# MATTERS FOR LIVERPOOL LOCAL PLANNING PANEL DETERMINATION

**LIVERPOOL CITY COUNCIL**  
**LOCAL PLANNING PANEL REPORT**

<b>ITEM No.</b>	<b>SUBJECT</b>	<b>PAGE No.</b>
<b>1</b>	<b>Development Application DA-933/2018</b>  <b>New additional indoor and outdoor seating for use with an existing restaurant (Food and Drink Premises).</b>  <b>Lot 300 DP 124755, Lot 201 DP 1224084</b> <b>Shop 3, 296-306 Macquarie Street, Liverpool</b>	<b>2-34</b>

<b>ITEM No.</b>	<b>SUBJECT</b>	<b>PAGE No.</b>
<b>3</b>	<b>Development Application DA-572/2019</b>  <b>Demolition of existing structures and construction of a mixed-use development comprising a four-storey residential flat building with 8 units and a two-storey 65-place childcare centre over two levels of basement carparking for 32 car spaces</b>  <b>Lot 38 and Lot 39 DP 228324</b> <b>22-24 Thompson Avenue, Moorebank</b>	<b>82-244</b>

**Figure 4:** Proposed seating layout (Source: Brad Ward Design, Ref: GF-DA-002L, date 23/08/2018)

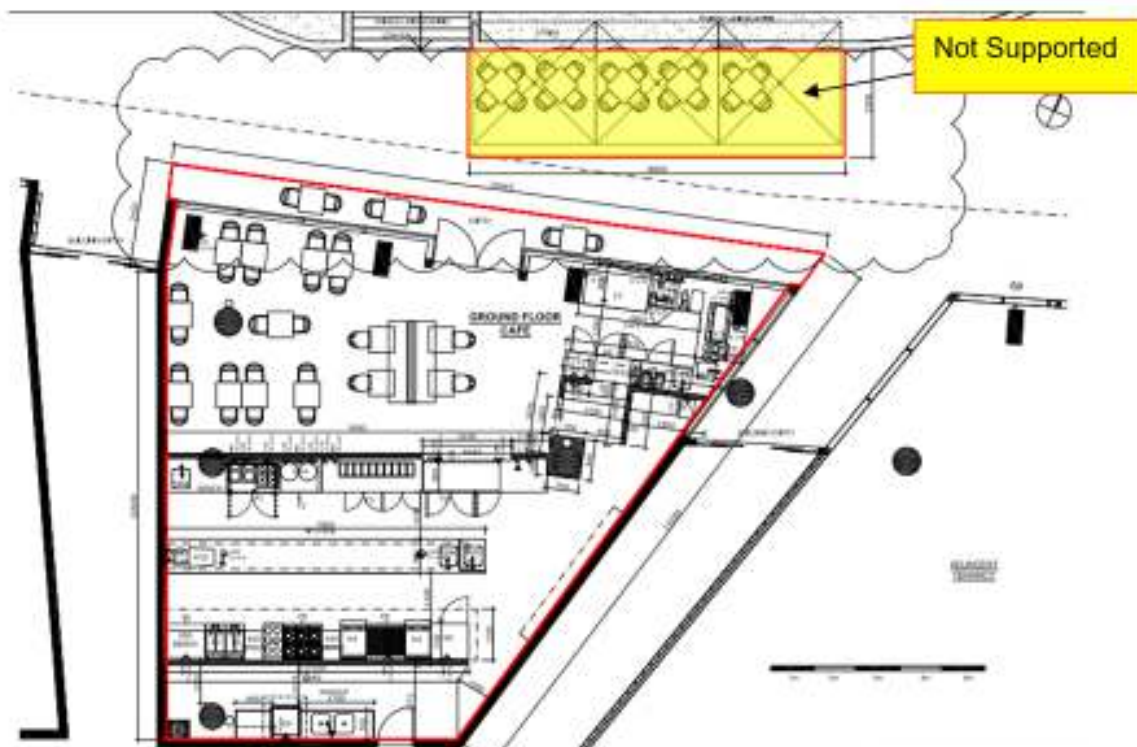
The outdoor dining area as indicated in figure 4 above, is located on land owned by Council. As a result land owners consent is required from Council for the purpose of outdoor dining and was provided by Council's Property Unit limiting the outdoor dining to under the existing awning of the subject building only, due to potential acoustic concerns.

The above plan is indicative only and outdoor dining is only permitted under the existing awning of the subject premises along the shopfront. No outdoor dining is permitted away from the shop front as highlighted on the plan above in yellow

- Indoor seating for 28 patrons is supported.
- External seating for 26 patrons is not supported
- The proposal is to provide outdoor dining under the awning only along the shopfront for a period of 12 months only.

**Figure 9:** Height plan study/rear elevation submitted with Clause 4.6 variation. (Maximum building height of 12m shown in dashed line) (Source: Clause 4.6 variation prepared by Think Planners).

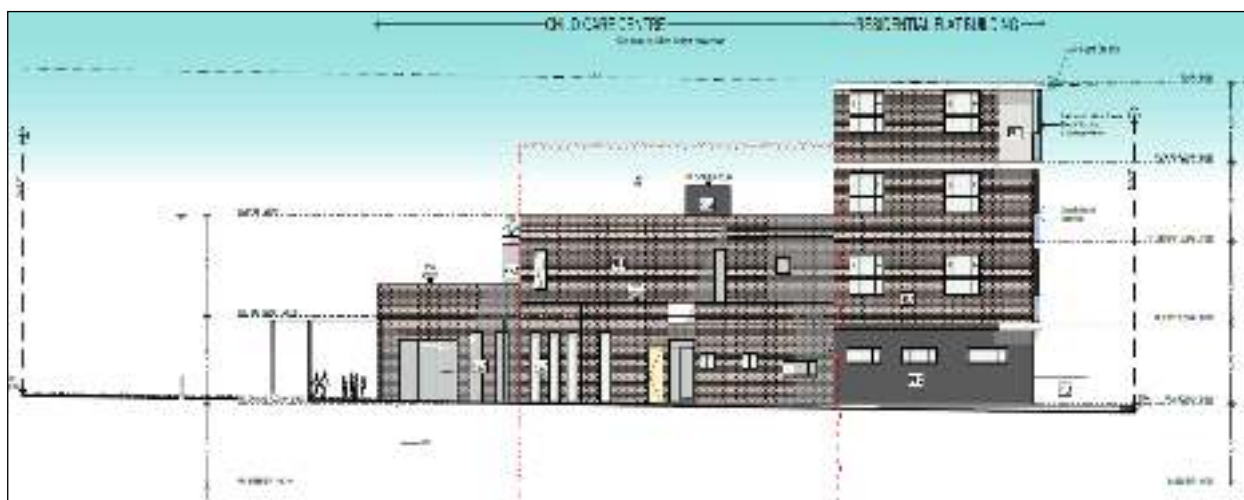
**Figures 8 and 9** below illustrate the 12m height plane and extent of non-compliance.

A variation to the height can be considered under Clause 4.6 – Exceptions to Development Standards of the LLEP 2008. In assessing the variation, the questions identified in Clause 4.6 have to be considered.

**Figure 10:** Shadow diagrams showing the context **Source:** Plan DA 21(issue C) as prepared by Design link Aust Pty Ltd.

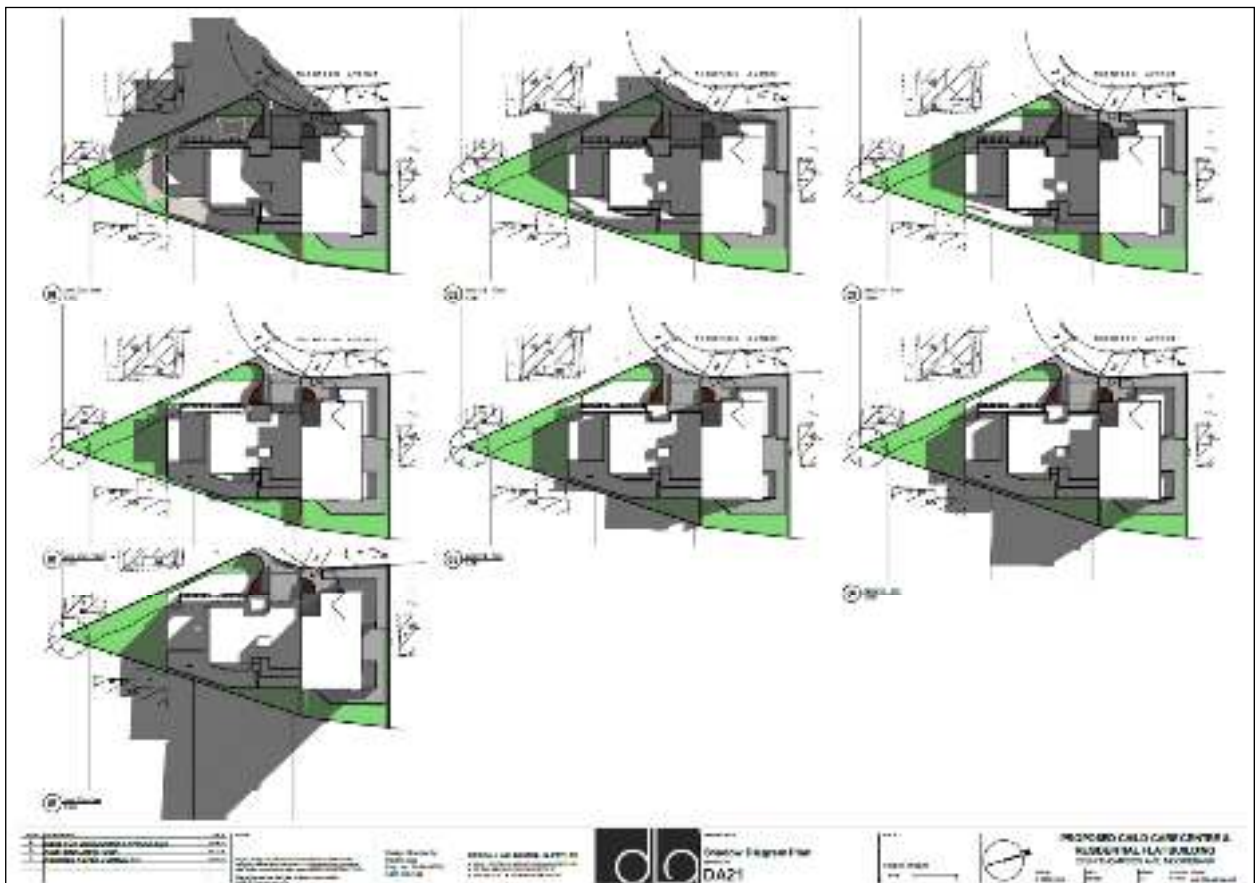
- The additional height to the development does not result in any additional privacy or shadow impacts to adjoining developments. Shadow diagrams submitted with the application show that adjoining developments will receive sunlight in excess of 3 hours between 9am and 3pm during mid-winter, as illustrated in the shadow diagrams (**Figure 11**) below. The additional shadows from the increased height of the building cast mainly on the roof of the development itself.
- The floor space ratio of the development complies with the relevant development standard which demonstrates that the height of the development is not a result of additional floor area being provided to the development.
- The proposed development is indicative of and consistent with future character and scale for the area where it is undergoing an urban transformation with high density development.

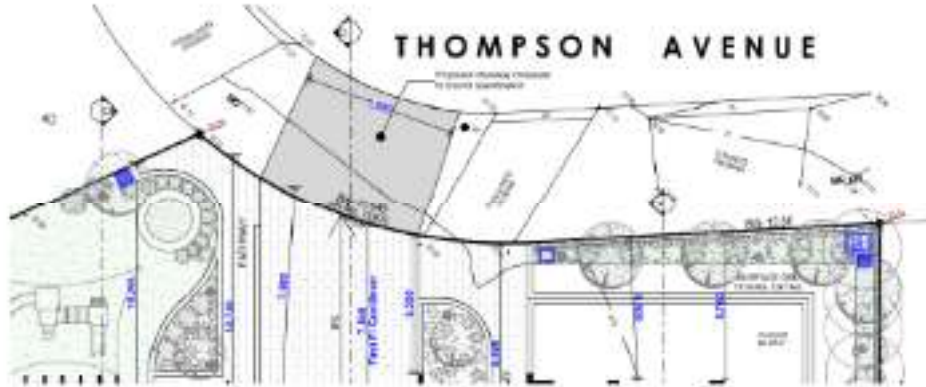
Telstra (and its authorised contractors) are the only companies that are permitted to conduct works on Telstra's network and assets. Any person interfering with a facility or installation owned by Telstra is committing an offence under the Criminal Code Act 1995 (Cth) and is liable for prosecution.

Furthermore, damage to Telstra's infrastructure may result in interruption to the provision of essential services and significant costs. If you are aware of any works or proposed works which may affect or impact on Telstra's assets in any way, you are required to contact: Telstra's Network Integrity Team on Phone Number 1800 810 443.
